Project	IEEE 802.16 Broadband Wireless Access Working Group < http://ieee802.org/16 >	
Title	Changes on Sleep Mode SDLs and MSCs	
Date Submitted	2003-10-31	
Source(s)	Chulsik Yoon, Kunmin Yeo ETRI 161 Gajeong-Dong, Yuseong-Gu, Daejeon, Korea	Voice: +82-42-860-6826 Fax: +82-42-860-6732 mailto: csyoon@etri.re.kr
Re:	This is a response to a Call for Comments IEEE 802.16e-03/23 on IEEE 802.16e-03/07r4	
Abstract	This document contains suggestions to change the SDLs and MSCs reflecting working groups agreements on the Sleep Mode operation.	
Purpose	The document is submitted for review by 802.16e Working Group members.	
Notice	This document has been prepared to assist IEEE 802.16. It is offered as a basis for discussion and is not binding on the contributing individual(s) or organization(s). The material in this document is subject to change in form and content after further study. The contributor(s) reserve(s) the right to add, amend or withdraw material contained herein.

Changes on Sleep Mode SDLs and MSCs

2. Proposed changes on Sleep Mode operation SDLs and MSCs in IEEE 802.16e-03/07r4

Figure 106a – MSS Awake Mode SDL Diagram

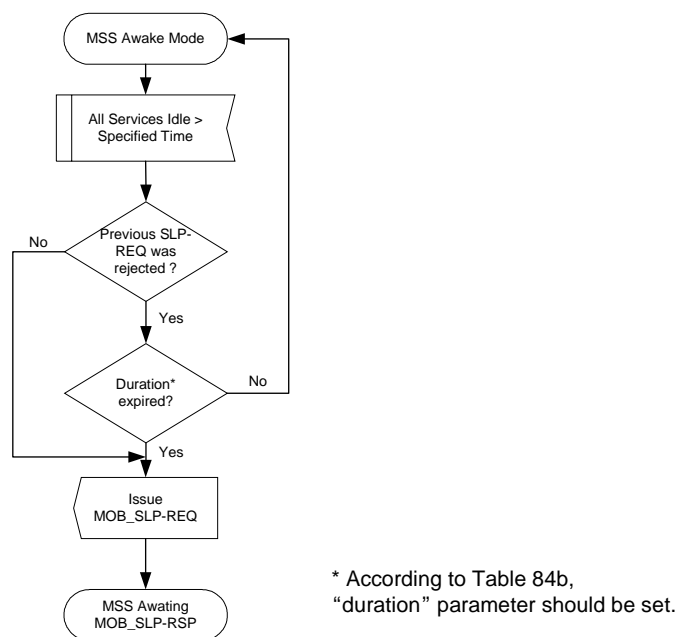
[Replace Figure 106a to the following:]

Figure 106c – MSS Sleep Mode SDL Diagram

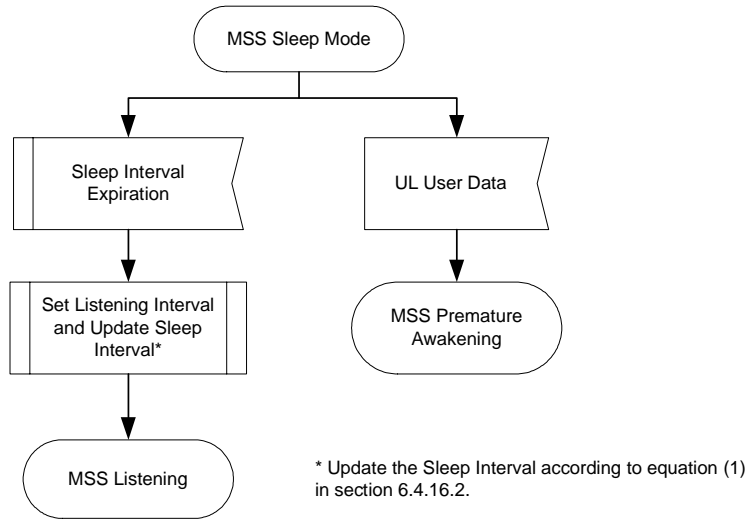
[Replace Figure 106c to the following:]

Figure 106d – MSS Listening SDL Diagram

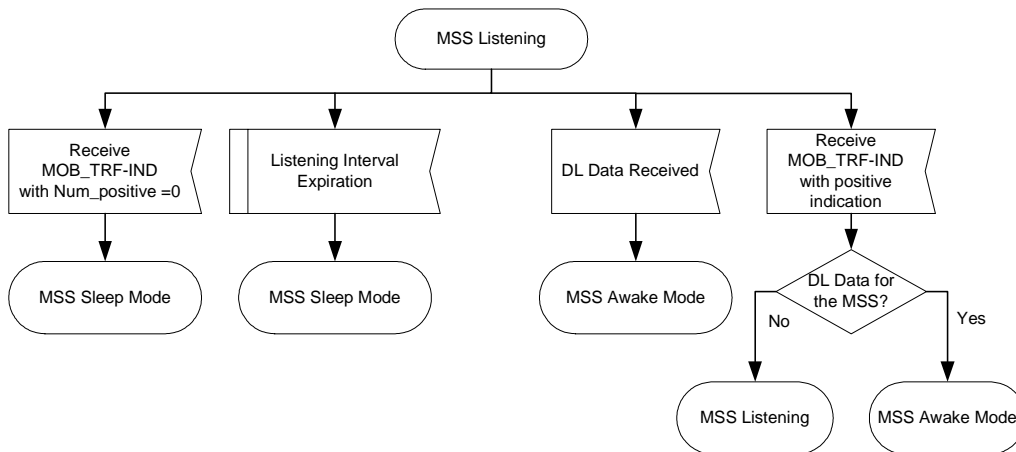
[Replace Figure 106d to the following:]

Figure D.10 – Sleep Mode – MSS initiated

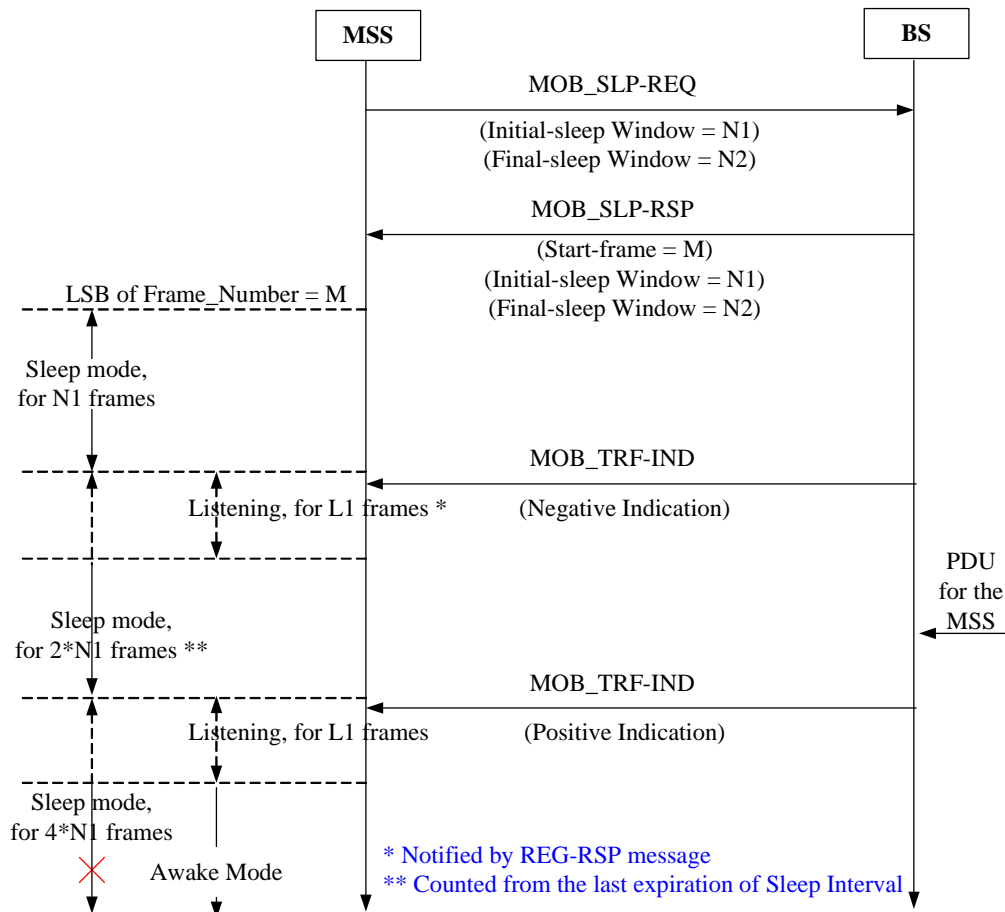
[Replace Annex D.2 Figure D.10 to the following:]

Figure D.11 – Sleep Mode – BS initiated

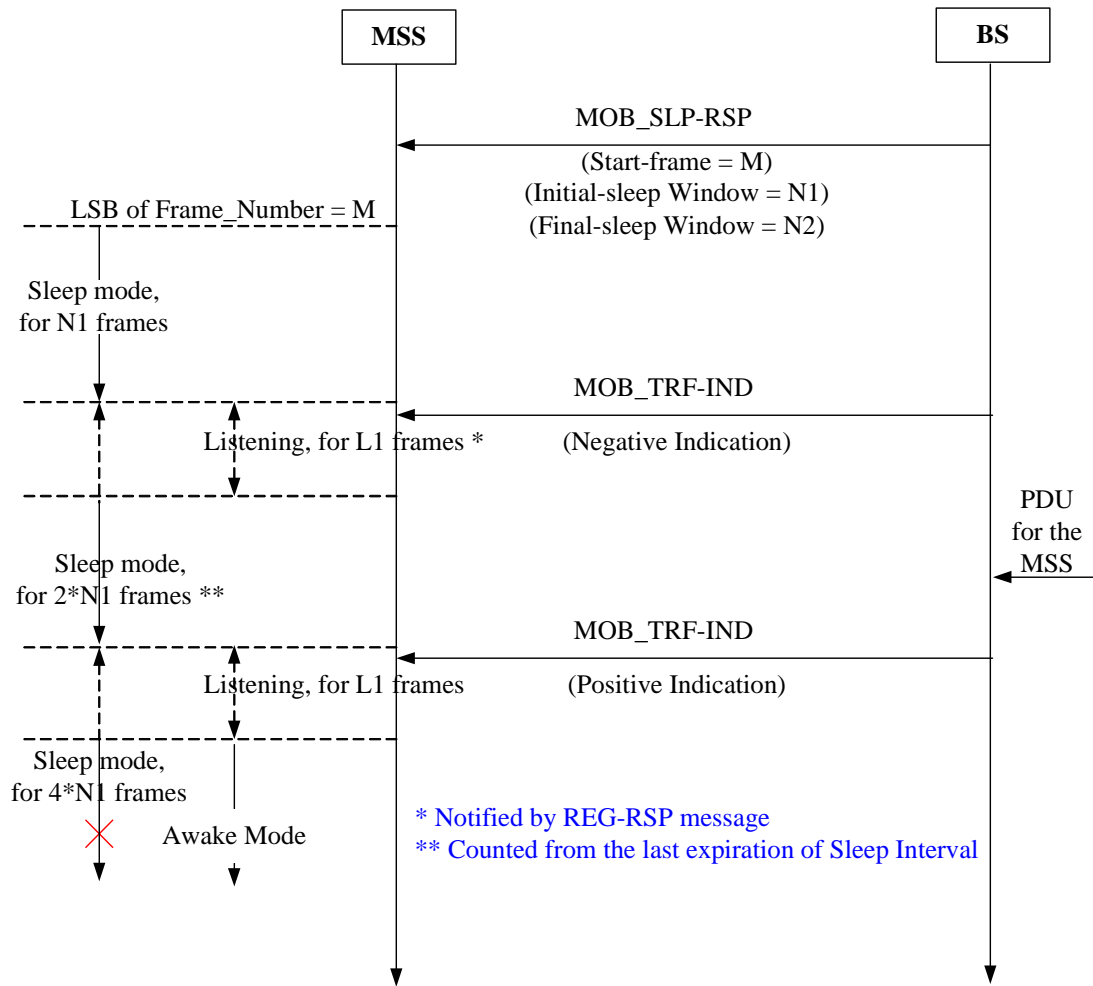
[Replace Annex D.2 Figure D.11 to the following:]

Figure D.12 – Sleep Mode – MSS initiated awakening

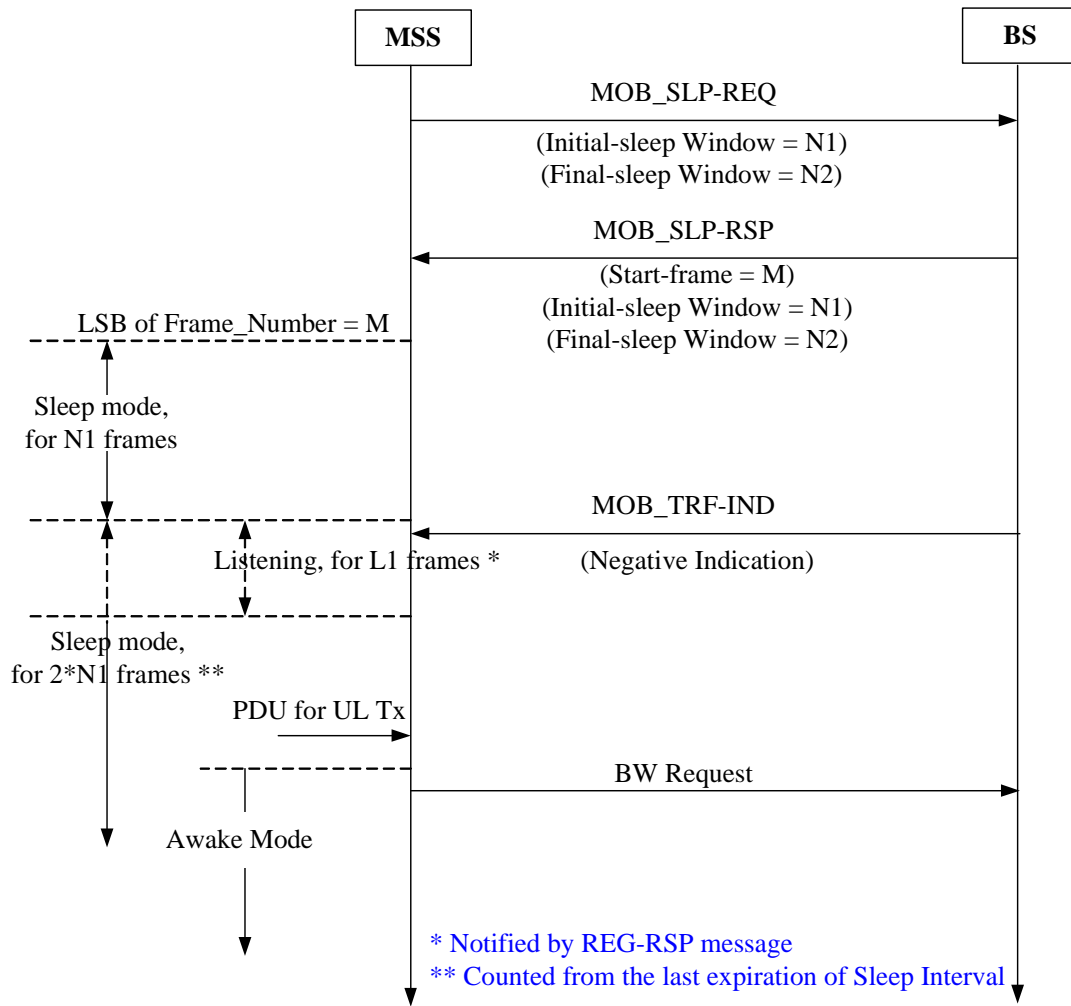
[Replace Annex D.2 Figure D.11 to the following:]
